SERVICE BULLETIN

ENGINE - GENERAL - PROVIDE VARIOUS REPLACEMENT EXTERNAL TUBES WITH RELOCATED TUBE SLEEVES - CATEGORY CODE 7 - MOD.ENG-72-0053

V2500-ENG-72-0053

No.4 oil weep tube (oil hydraulic and water drain tube) Before and after alteration
Fig.1

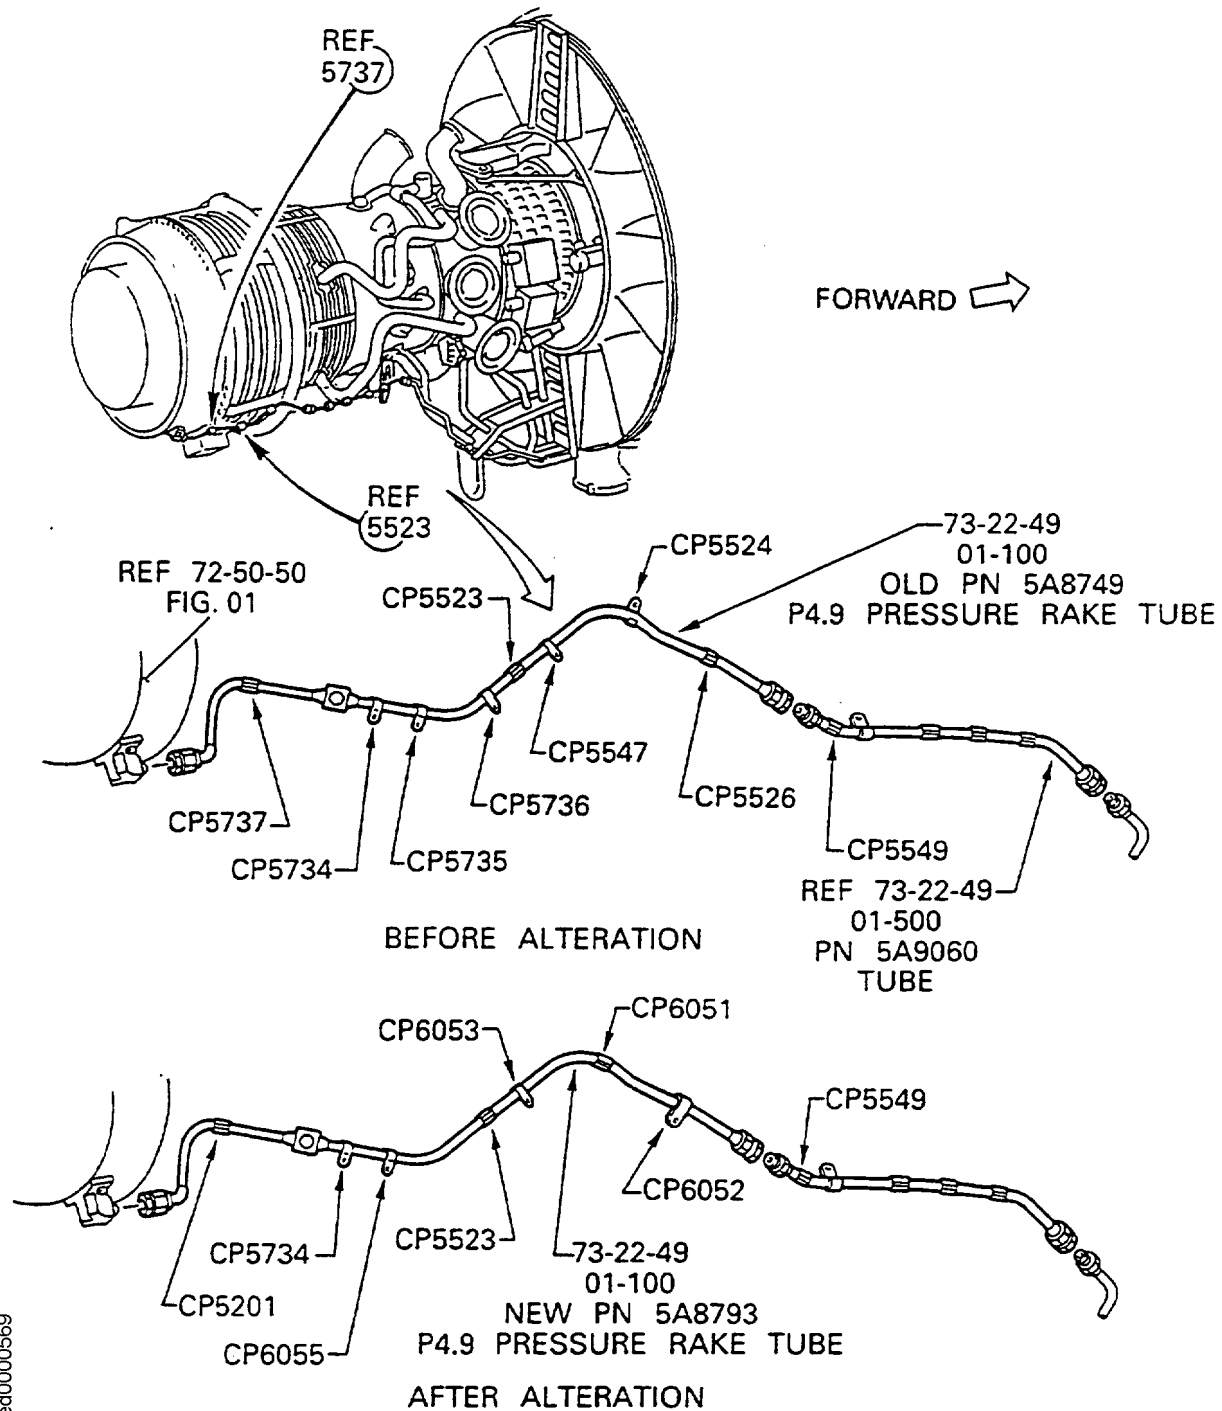
- (a) 5R8083 tube (71-73-49, 01-500), 5A8749 tube (73-22-49, 01-100) and 5R8225 tube (79-21-49, 16-100) have been re-routed with the relocated sleeves. Refer to section 2: Figures 1, 2 and 3.
- (b) The existing clipping points, CP5524, CP5525, CP5526, CP5547, CP5735, CP5736 and CP5737 have been deleted. Refer to section 2: Figures 5, 9, 11, 12, 13, 16 and 17.
- (c) New clipping points, CP6050, CP6051, CP6052, CP6053, CP6054 and CP6055, have been introduced in place of the deleted clipping points. Refer to section 2: Figures 10, 18, 19, 20, 21 and 22.
- (d) The clipping configurations at CP5201, CP5206, CP5523, CP5549 and CP5734 have been slightly changed. Refer to section 2: Figures 5, 6, 7, 8, 14 and 15.

- (1) Install new 5W8392 bracket to the engine. Refer to Figure 4.
 - (2) Put new 5R8143 tube in position on the engine. Refer to Figure 1.
 - (a) Connect new 5R8143 tube to 5R8226 tube and the LP turbine case connector.

- (b) Torque the tube nuts to 159 to 177 lbfin (18 to 20 Nm) and safety with CoMat 02-126 lockwire.
 - (3) Put new 5A8793 tube in position on the engine. Refer to Figure 2.

P4.9 pressure rake tube (fuel system air tubes) Before and after alteration
Fig.2

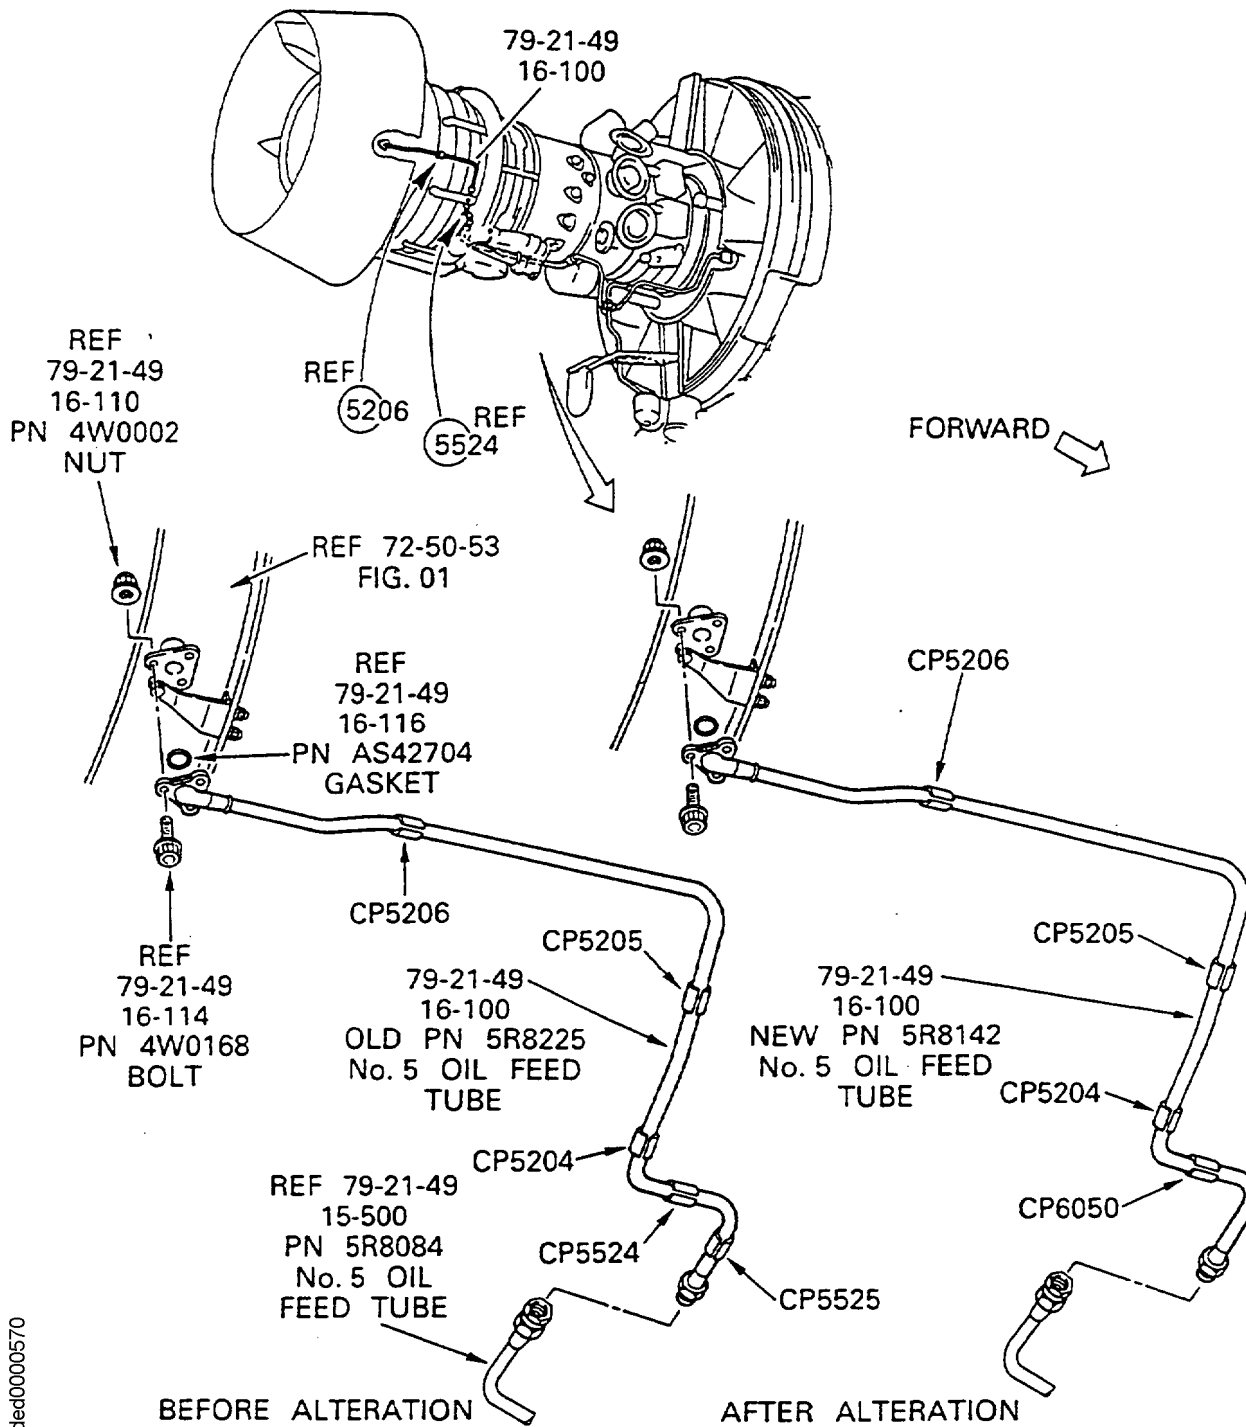
- (a) Connect new 5A8793 tube to the pipe adaptor and 5A9060 tube.
 - (b) Torque the two tube nuts to 159 to 177 lbfin (18 to 20 Nm) and safety with CoMat 02-126 lockwire.

No.5 oil feed tube (pressure oil tubes - engine) Before and after alteration
Fig.3

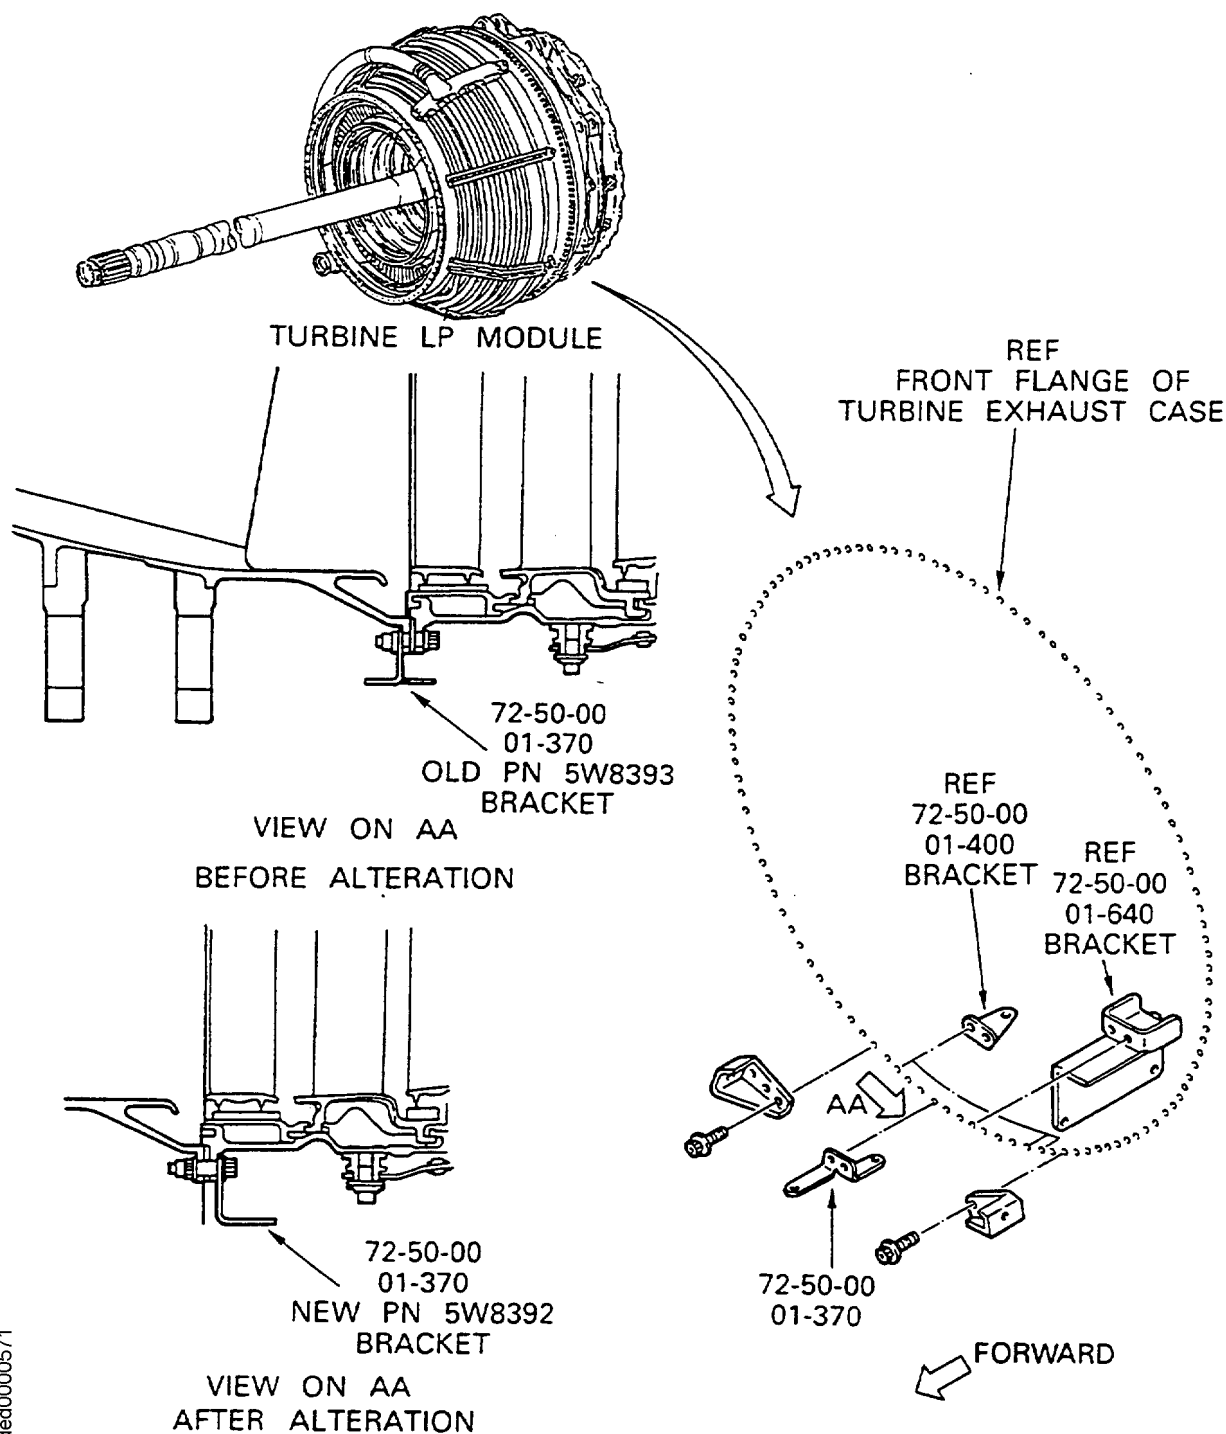
- (4) Put new 5R8142 tube in position on the engine. Refer to Figure 3.
 - (a) Connect new 5R8142 tube to the outer oil feed tube. Put AS42704 gasket in the correct position.

- (b) Install 4W0168 bolts (3 off) and 4W0002 nuts (3 off).
 - (c) Torque the nuts to 85 to 105 lbfin (10 to 12 Nm).
 - (d) Torque the tube nut to 230 to 248 lbfin (26 to 28 Nm) and safety with CoMat 02-126 lockwire.

Bracket - Turbine, LP module Before and after alteration
Fig.4

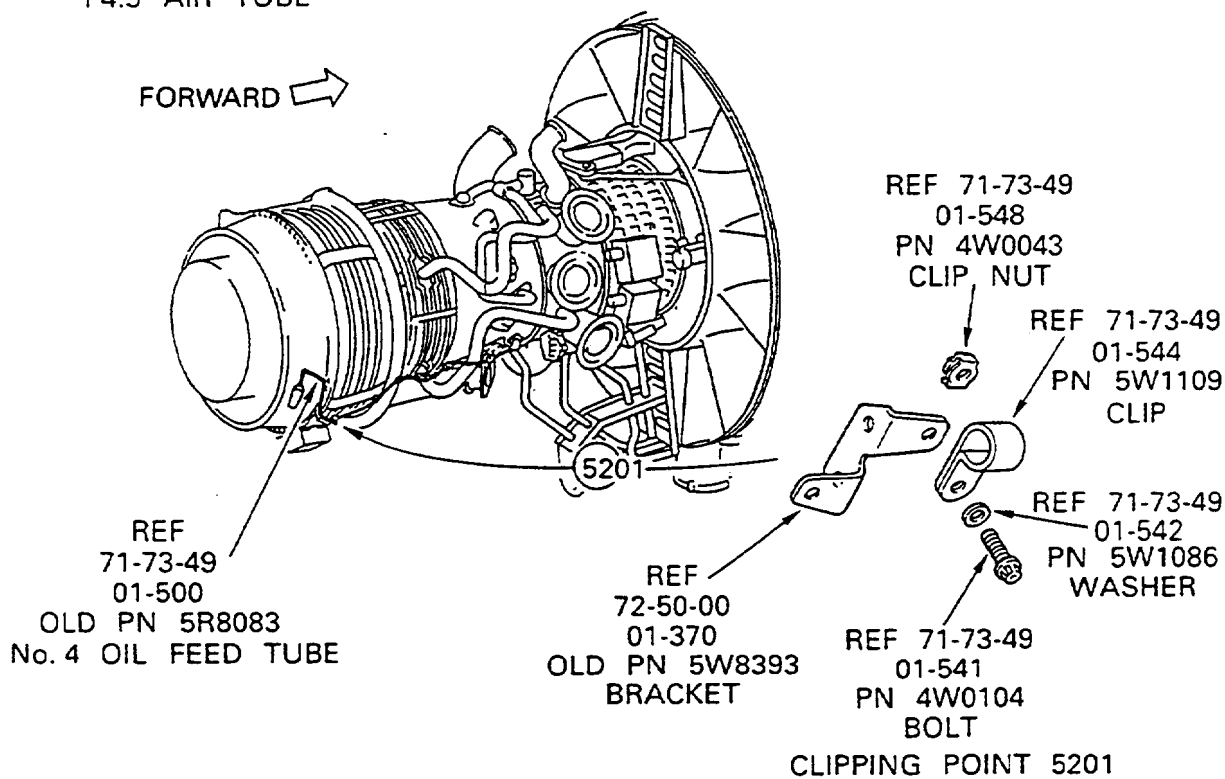
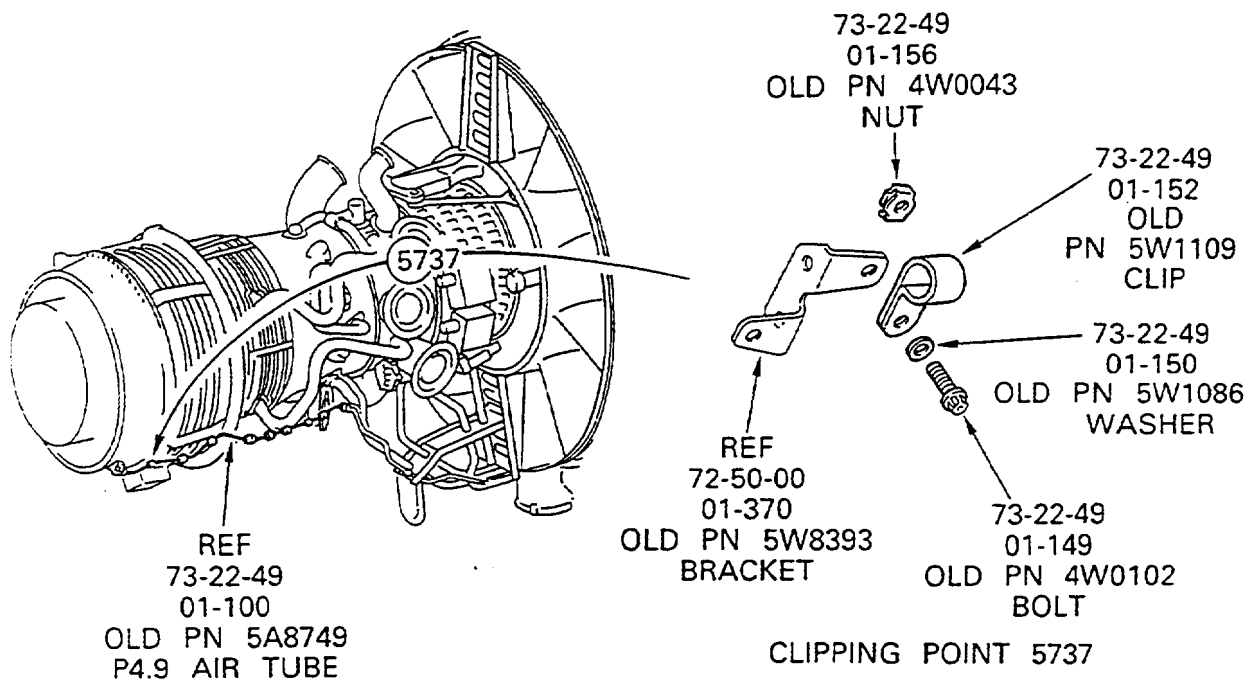
(c) The existing 5W8393 bracket (72-50-00, 01-370) has been changed to the new bracket to hold the P4.9 pressure rake tube and the oil weep tube at CP5201. The existing 5W8393 bracket holds both tubes at CP5737 and at CP5201. refer to section 2: Figure 4.

Clipping point 5206 - Before and after alteration
Fig.7

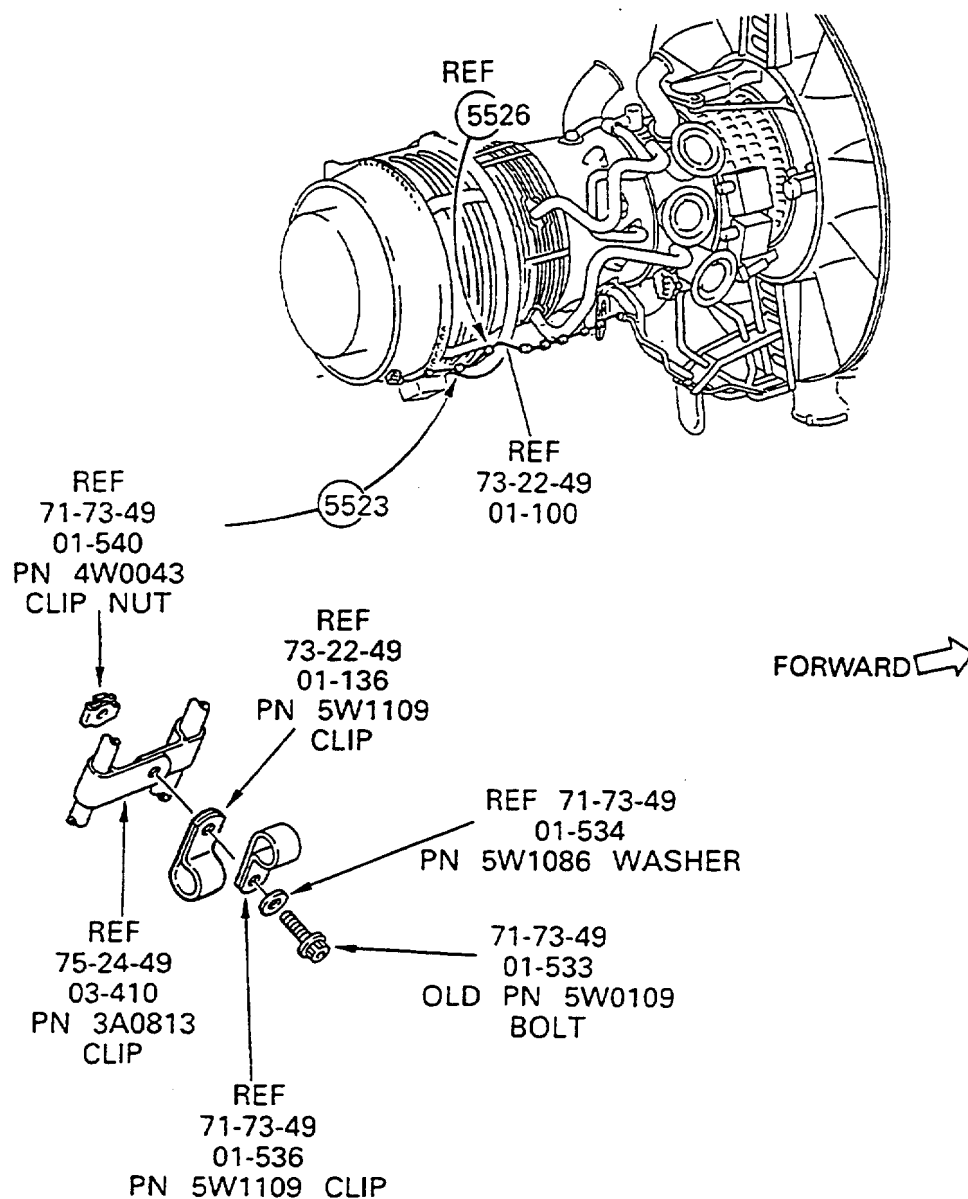
- (i) At CP5206, install 5W1110 clip, 4W0043 nut, 5W1086 washer and new 4W0102 bolt to the bracket and the No.5 oil feed tube. Refer to Figure 7.
- (j) At new CP6050, install new 5W1109 clip, new 4W0001 nut, new 5W1086 washer and new 4W0103 bolt to the lug on the No.5 oil feed tube and the No.4 oil weep tube. Refer to Figure 10.
